UNITED STATES PATENT AND TRADEMARK OFFICE

APPLICATION NO.	FILING DATE	FIRST NAMED INVENTOR	ATTORNEY DOCKET NO.	CONFIRMATION NO.
10/597,711	09/26/2006	Ove Kornelius Guttormsen	RR-630 PCT/US	5255
20427	7590	05/28/2009	EXAMINER	
RODMAN RODMAN 10 STEWART PLACE SUITE 2CE WHITE PLAINS, NY 10603			AMIRI, NAHID	
			ART UNIT	PAPER NUMBER
			3679	
			MAIL DATE	DELIVERY MODE
			05/28/2009	PAPER

DETAILED ACTION

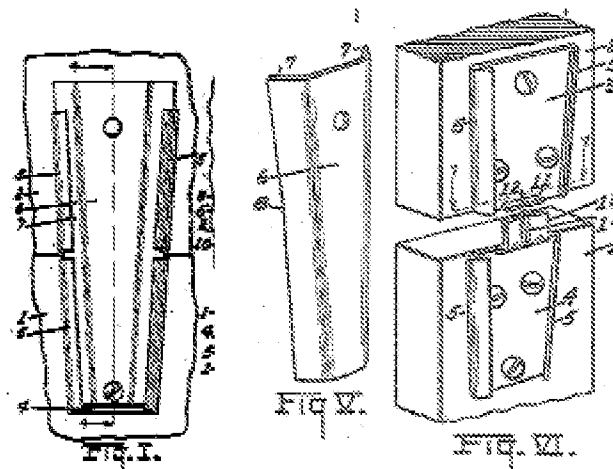
Claims 1 and 12 are rejected under 35 U.S.C. 102(b) as being anticipated by US Patent No. 1,182,610 Wiesman.

With respect to claim 1, Wiesman discloses a device (Figs. I, V, VI, VIII) for connecting structural elements (1, 2), the device consisting of a male component (M) and a female component (constituted by a wedge 6) having at least over a part of their length wedge-shaped engaging parts having an almost dovetail-shaped, gradually decreasing cross-section, and wherein the male component (M) and the female component (6) are mountable on a face or edge

of the structural elements (1, 2) in order, on movement of the structural elements (1, 2) relative to each other, to cause the male and female components (M, 6) to engage wedgingly, characterised in at least a first abutment portion (constituted by a flange 5) is formed on the male component (M) and at least second abutment portion (constituted by a diverging flange 7) on the female component (6) for edge-to-edge abutment against each other when the male component (M) and the female component (6) are engaged a predetermined amount, the edge-to-edge abutment being made to prevent the male component (M) from penetrating wedgingly to the maximum into the female component (6), thereby avoiding mutual deformation of the male and female components (M, 6) or material strain thereof on penetration.

With respect to claim 12, it should be noted that the claims are drawn solely to a device subcombination that includes recitations of intended use for connecting to the structural members. Patentability determination is based on the device recited and not how the device is intended to be used. Thus, it is structure of the device, alone, that is considered. Wiesman discloses (Fig. VI) that the male and female components (M, 6) are attached to a respective profiled attachment fitting (constituted by screws 19) which is securable at least one end portion of a respective structural member.

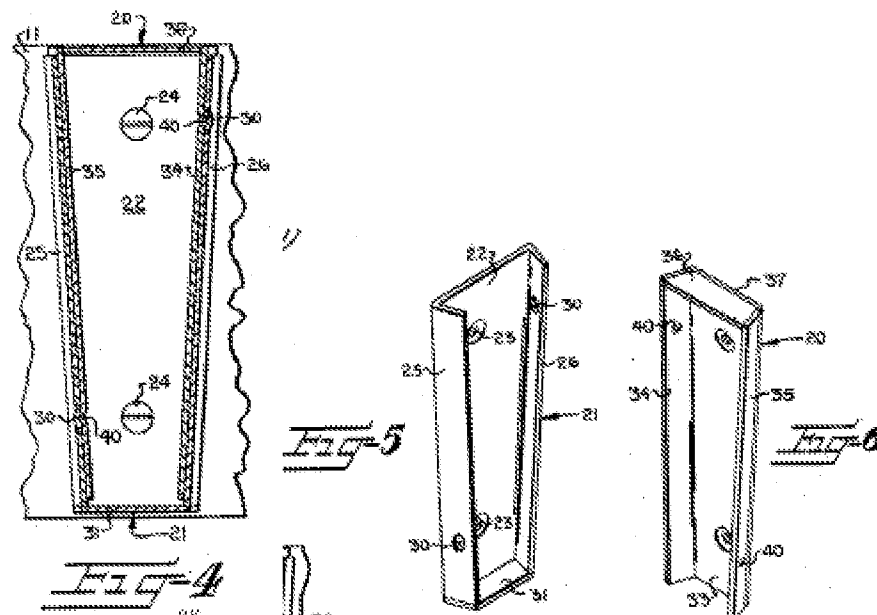
Claims 1 and 12 are rejected under 35 U.S.C. 102(b) as being anticipated by US Patent No. 2,793,407 Johnston.

With respect to claim 1, Johnston discloses a device (Figs. 4-6) for connecting structural elements (10, 11), the device consisting of a male component (20) and a female component (21) having at least over a part of their length wedge-shaped engaging parts having an almost dovetail-shaped, gradually decreasing cross-section, and wherein the male component (20) and the female component (21) are mountable on a face or edge of the structural elements (10, 11) in order, on movement of the structural elements (10, 11) relative to each other, to cause the male and female components (20, 21) to engage wedgingly, characterised in at least a first abutment portion (constituted by a flange 25) is formed on the male component (20) and at least second abutment portion (constituted by a flange 34) on the female component (21) for edge-to-edge abutment against each other when the male component (20) and the female component (21) are engaged a predetermined amount, the edge-to-edge abutment being made to prevent the male component (20) from penetrating wedgingly to the maximum into the female component (21), thereby avoiding mutual deformation of the male and female components (20, 21) or material strain thereof on penetration.

With respect to claim 2, Johnston discloses (Figs. 4-6) that the second abutment portion (34) has two lugs (constituted by knobs 40) and said first abutment portion (25) includes corresponding abutment edge portions, said lugs (40) being arranged to abut against and be supported by the corresponding abutment edge portions on the wedge said male component (20). Johnston fails to disclose that the two lugs positioned on the first abutment portion of the female member. It is well known in the art to provide the lugs at either the first or second abutment portions for the reasons well known in the art. It would have been obvious to one of ordinary skill in the art at the time of invention was made to provide the first abutment portion of Johnston instead of the second abutment portion with two lugs, since it has been held that rearranging parts of an invention involves only routine skill in the art. *In re Japikse*, 86 USPQ 70 (CCPA 1950).

With respect to claim 3, Johnston discloses (Figs. 4-6) that the second abutment portion (34) has two lugs (constituted by knobs 40) that extend out to the side from a portion arranged in continuation of one of the wedge-shaped engaging parts, and that the female component (20) said second abutment portion (25) similarly has a portion an abutment surface arranged in continuation of its wedge-shaped engaging part in order to abut against and support said lugs (40). It is well known in the art to provide the lugs at either the first or second abutment portions for the reasons well known in the art. It would have been obvious to one of ordinary skill in the art at the time of invention was made to provide the first abutment portion of Johnston

instead of the second abutment portion with two logs, since it has been held that rearranging parts of an invention involves only routine skill in the art. *In re Japikse*, 86 USPQ 70 (CCPA 1950).
